HISTORIC AND DESIGN REVIEW COMMISSION

June 03, 2020

HDRC CASE NO: 2020-223
ADDRESS: 1174 E COMMERCE ST
LEGAL DESCRIPTION: NCB 14082 BLK 2 LOT 4 (EXCEPT S IRR 147.42 FT (.442 A), S IRR 96.39 FT (.236 A) & W IRR 312.5 FT (1.313 A)
ZONING: D, H
CITY COUNCIL DIST.: 2
DISTRICT: St Paul Square Historic District
LANDMARK: Southern Pacific Railroad Station
APPLICANT: Lisa Hernandez
OWNER: Don Thomas/VIA METROPOLITAN TRANSIT
TYPE OF WORK: Signage
APPLICATION RECEIVED: May 14, 2020
60-DAY REVIEW: Not applicable due to City Council Emergency Orders
CASE MANAGER: Edward Hall

REQUEST:

SIGN A	Sunset Station	OPTION 1
Type:	Aluminum/ Vinyl	
Illumination:	Non-Illuminated	
Square Footage:	5.29

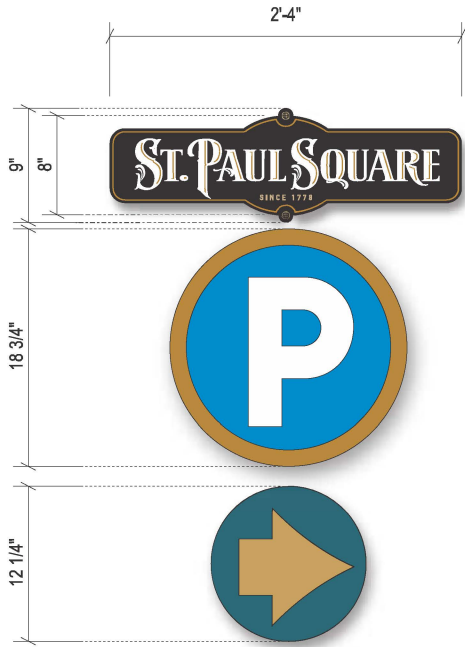
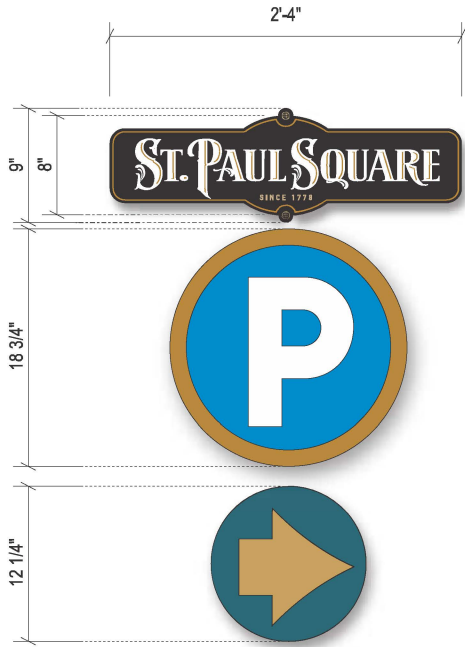
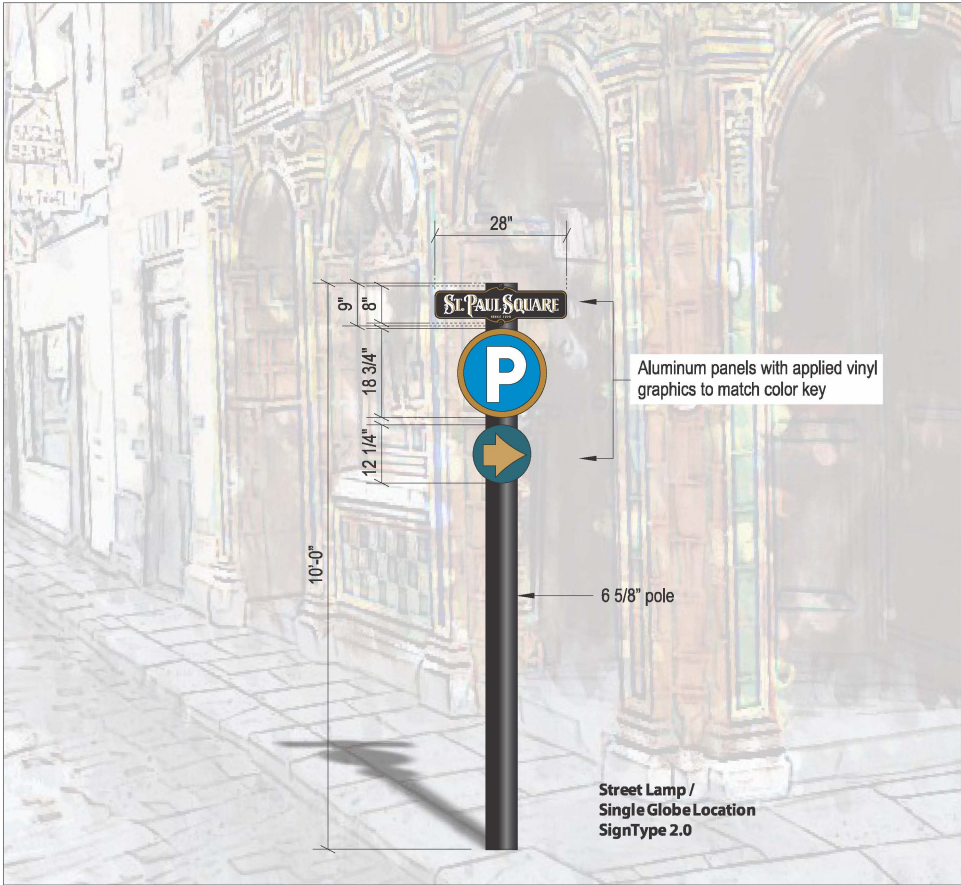
- d. **DIRECTIONAL SIGNAGE** – The applicant has proposed to install parking signs throughout the district that are to feature text that reads “St Paul Square” as well as feature directional parking signage. Generally, staff finds these signs to be appropriate, as they will be attached to existing light poles.

1. That option 1 be used for the proposed blade sign.
2. That the proposed freestanding, parking signs that will be attached to new poles be no taller than six (6) feet in height.

SIGN C	Espee Archway Signage
Sign Type:	Open-face Individual Front Lit CL's w/ self contained power on routed contour Backer
Illumination:	Contour LED's
Square Footage:	55.75

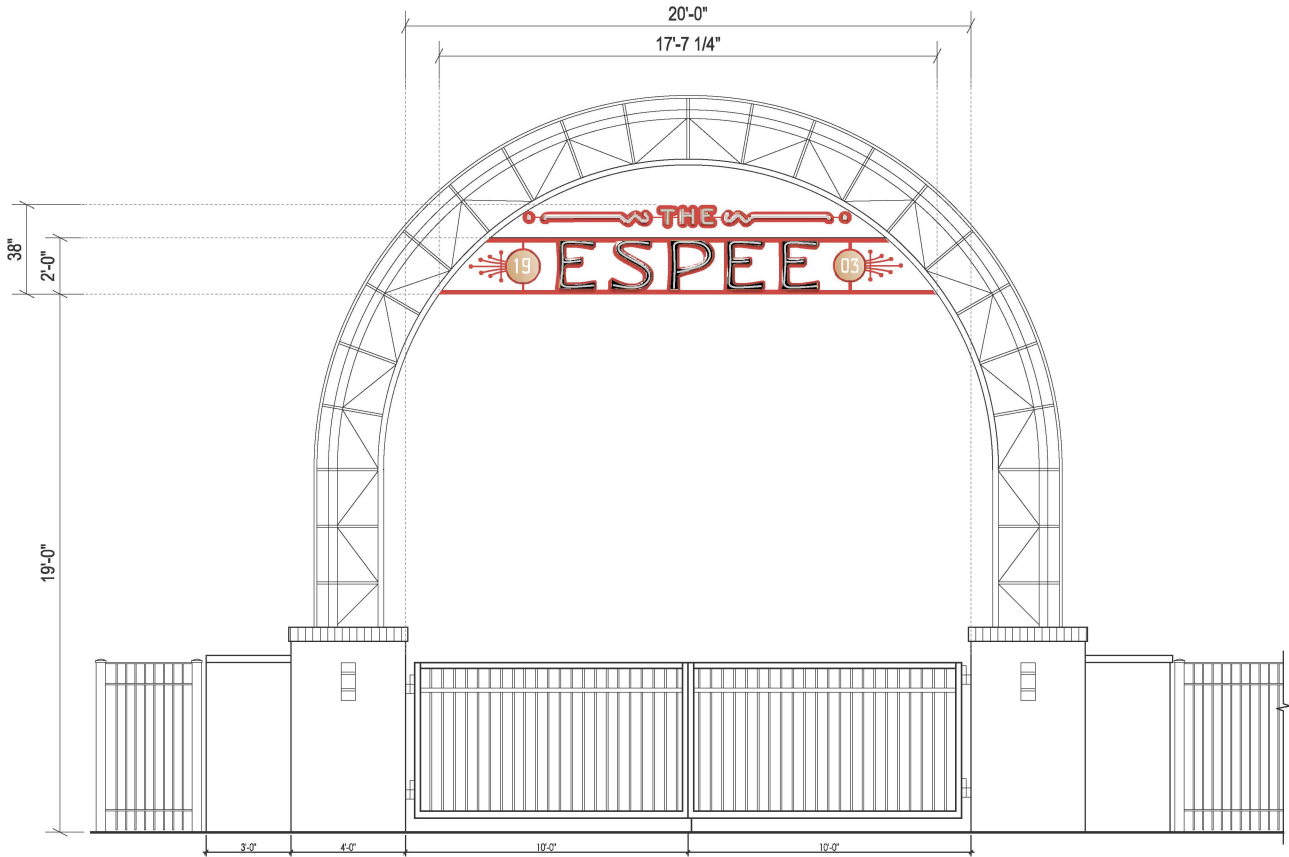
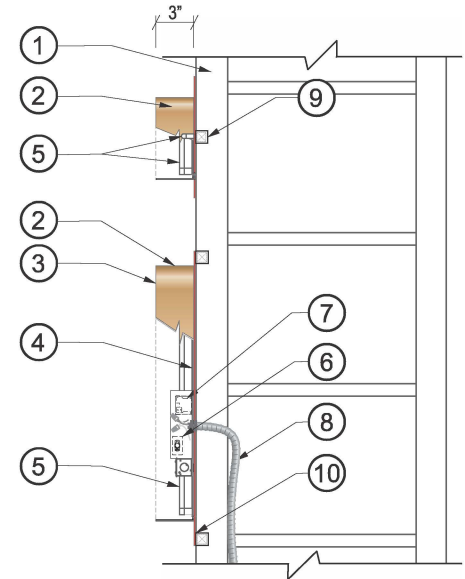
- c. **CHANNEL LETTER SIGN** – The applicant has proposed to install an open face channel letter sign on the previously approved steel archway to feature individually lit channel letters. The proposed signage will feature an overall size of approximately 56 square feet. The applicant has submitted a night rendering of the proposed sign, and generally, staff finds it to be appropriate given the size of the venue and existing archway.

SIGN D	14'-0" - Espee Blade Sign	OPTION 1
Sign Type:	D/F Blade Sign	
Illumination:	Contour LED's	
Square Footage:	43.46

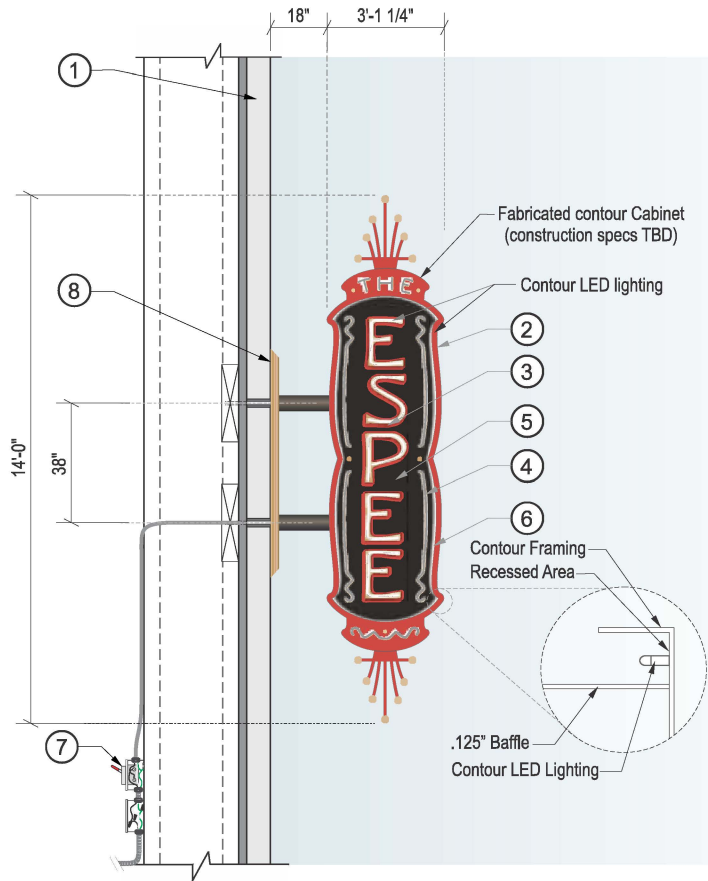
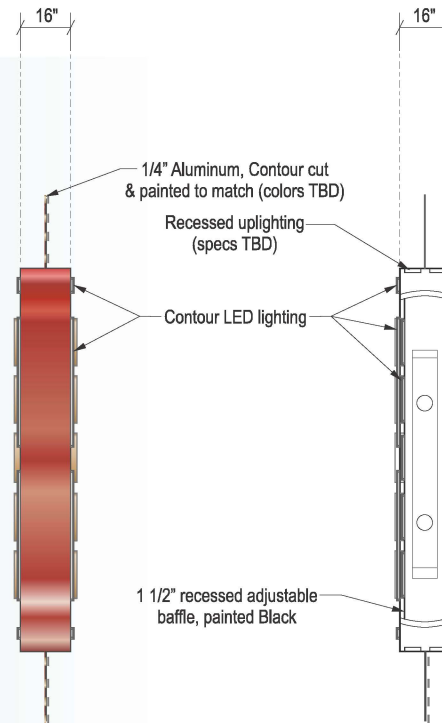
- b. **BLADE SIGN** – The applicant has proposed to install a blade sign to be installed on the west façade of the historic structure commonly known as Sunset Station. The proposed sign will be internally illuminated; however, will feature metal faces and will not produce a glowing cabinet. The applicant has submitted various options for review; however, staff finds option 1, which features an overall square footage of less than fifty (50) square feet to be the most appropriate.
